**Re: BOWDENS SILVER PROJECT (AMENDMENT REPORT) - APPLICATION
NUMBER SSD-5765**

Attached is the Objection by Lue Action Group (**LAG**) to the Amendment as lodged by Bowden's Silver Project (Bowden's) to *State Significant Development [SSD]* – 5765 detailed within the Amendment Report for the Bowdens Silver Project (R.W. Corkery & Co. Pty. Limited, July 2021).

Technical Review – Visual Assessment (SSD-5765)

Project:	N4006_001 Bowdens Silver Visual Radial Analysis	Date:	18 August 2021
To:	Lue Action Group	From:	Rod Williams
ATT:	Phil English	CC:	Click or tap here to enter text.
Subject:	Visual Radial Analysis – Proposed Transmission Line

TOWER 2 CROSS SECTION

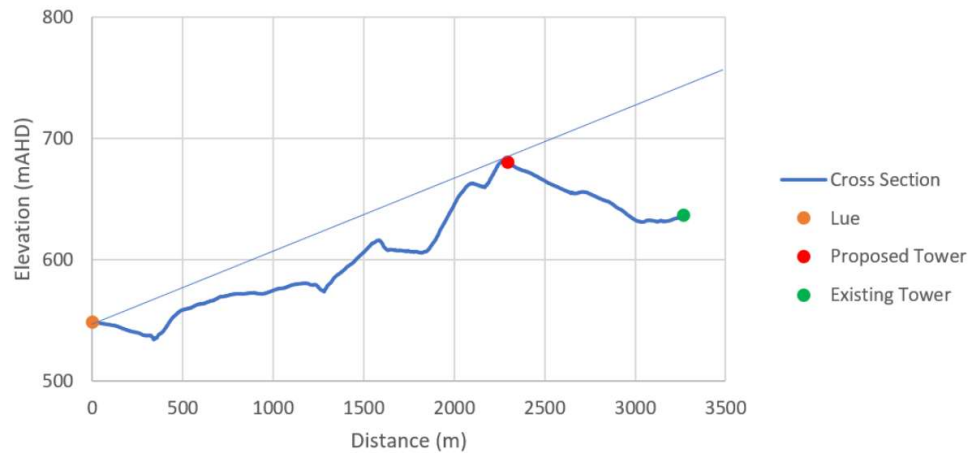
The cross-sections as undertaken by Engeny and included below highlight concerns maintained by LAG relating to the visual impact from the realignment.

In what appears to be a significant discrepancy within their conclusions, Engeny determined that the Visual Impact from the realignment to be extremely significant to the Village of Lue and its surrounding areas.

“Based on this analysis it is expected that approximately 50% of the proposed re-aligned power transmission line will be clearly visible from the vast majority if not all receivers in the Lue Village and surrounding area. This represents a significant change the viewshed characteristics for the Lue Village and surrounding receivers, compared to the current situation.”

Figure 1 Potential Visual Catchments (Source Richard Lamb 2020)

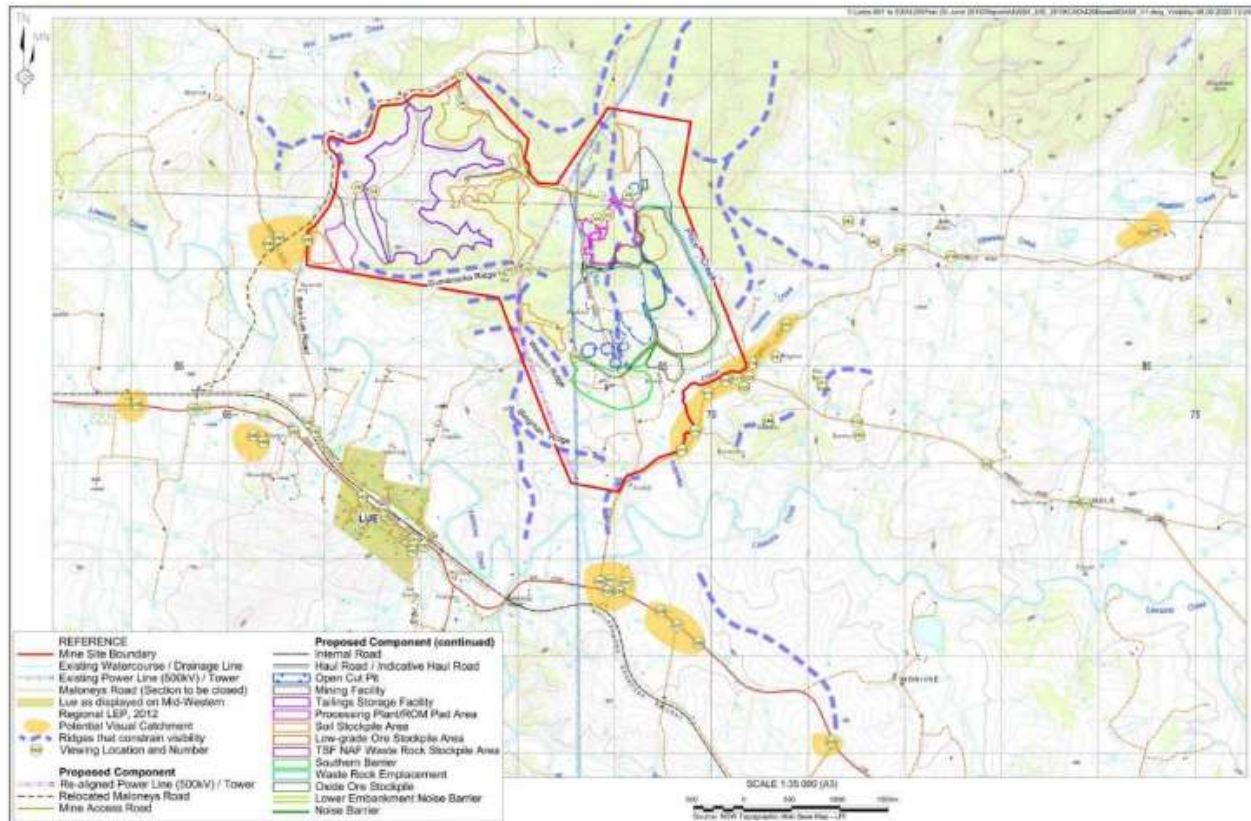
The village of Lue is located to the southern west of the proposed mine and the re-aligned power transmission line. Views from the Lue general area to the Northeast (i.e. towards the existing power transmission line) are completely screened by the existing natural topography (see Figure 1). Three cross sections from Lue to the existing transmission line alignment confirm that the views from Lue towards the Northeast are screened by the natural topography (see Figure 2, Figure 3 and Figure 4).

Figure 2 Tower 1 Cross Section

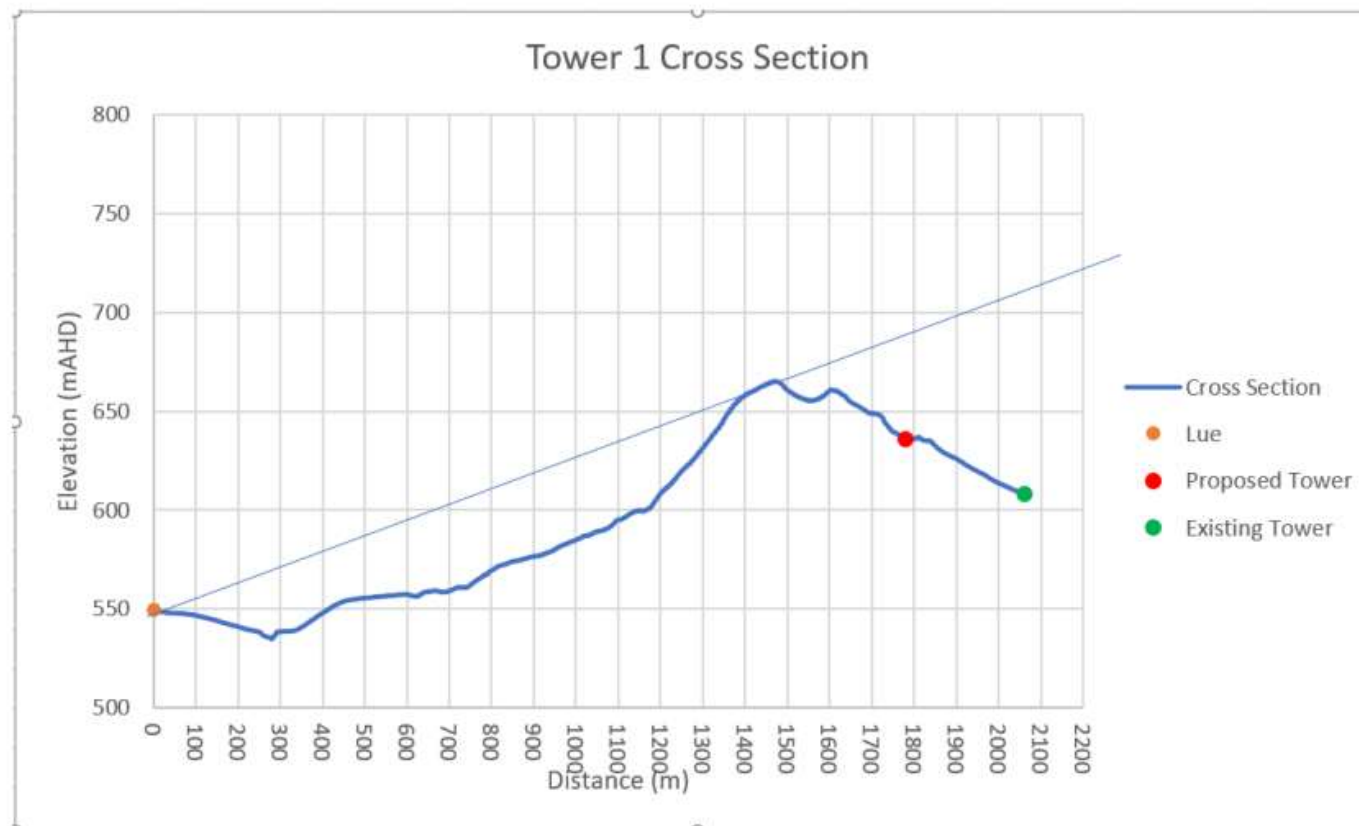
Radial analysis of three tower locations (assuming a tower height of 60m and a viewshed of 5 kilometres from the tower) along the re-aligned power transmission line alignment has been undertaken to assess the extent to which the proposed towers will be visible from the general area of Lue (see Figure 5, Figure 6 and Figure 7). The Tower 1 radial analysis (see Figure 5) and cross section (see Figure 2) indicates that the top portion of Tower 1 will be visible from the Lue general area. However, this assumes that there is no screening provided by the existing vegetation, which is not the case. As such Tower 1 is unlikely to be

Figure 3 Tower 2 Cross Section

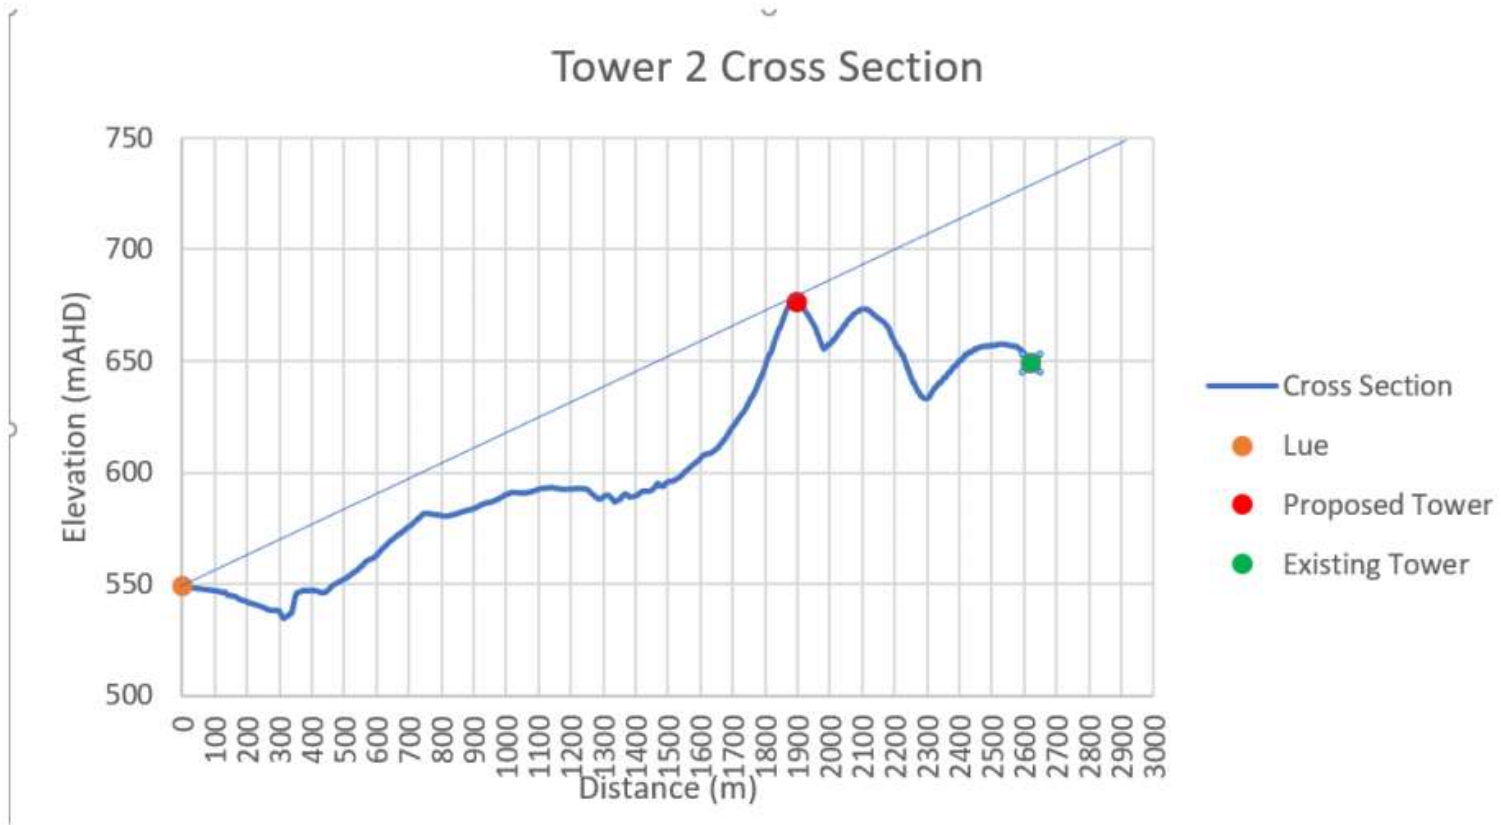
visible from the Lue general area. Towers 2 and 3 are however located on the top of the ridgeline (see Figure 3 and below Figure 4) and as such will be clearly visible from the Lue Village and surround area (see Figure 6 and Figure 7). The visibility of the proposed power transmission line alignment would be further increased by the clearance of vegetation within the powerline easement. The extent of vegetation clearance required has not been defined in any of the documents reviewed or the contribution to the visual impact assessed.

Figure 6 Tower 2 Radial Analysis

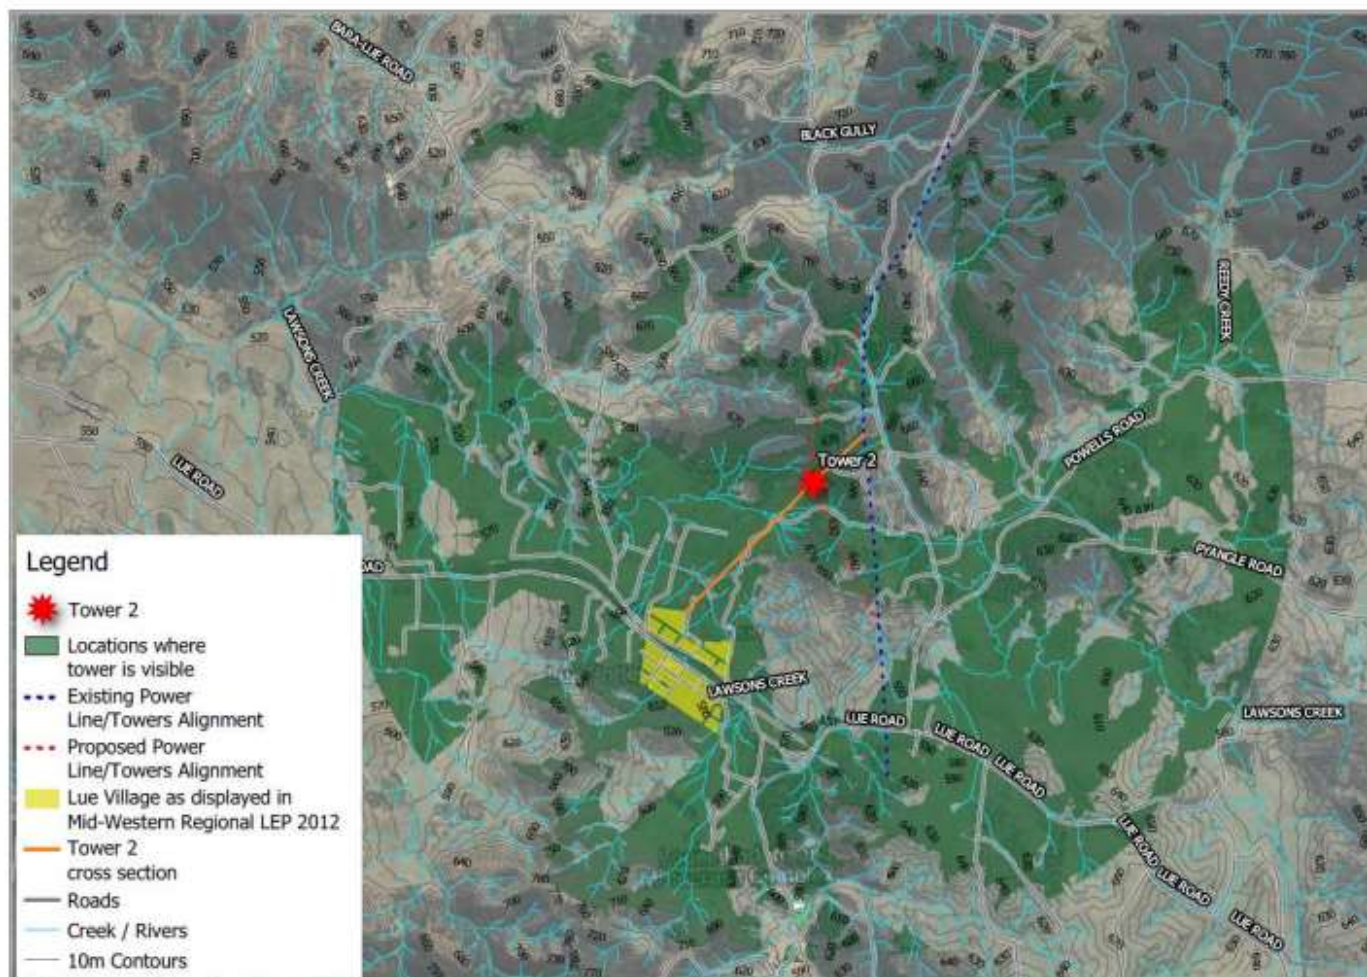
Based on this analysis it is expected that approximately 50% of the proposed re-aligned power transmission line will be clearly visible from the vast majority if not all receivers in the Lue Village and surrounding area. This represents a significant change the viewshed characteristics for the Lue Village and surrounding receivers, compared to the current situation.
